**STAFF REPORT:** OCTOBER 11, 2023, REGULAR MEETING

**APPLICATION NUMBER:** HDC2023-00056

**ADDRESS:** 226 MACK

**SCOPE:** REPLACE WOOD AND VINYL WINDOWS WITH ALUMINUM-CLAD WOOD WINDOWS

*September 2023 photo by staff.*

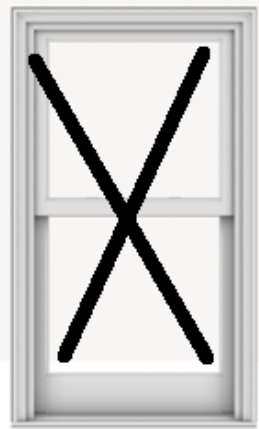
226 Mack is a two-and-one-half-story, side-gabled house, built in 1927. The irregular placement of window openings adds interest to all facades; this includes a dominant, five-faceted bay window on the primary (north) façade, box bay windows on the primary façade and east elevations, and segmental dormers on the front-facing roof slope. The only remaining historic wood windows are a row of four, one-over-one sash windows on the box bay window that projects from the east wall, and two small windows on the west elevation. All other windows are either vinyl replacements or are missing entirely.
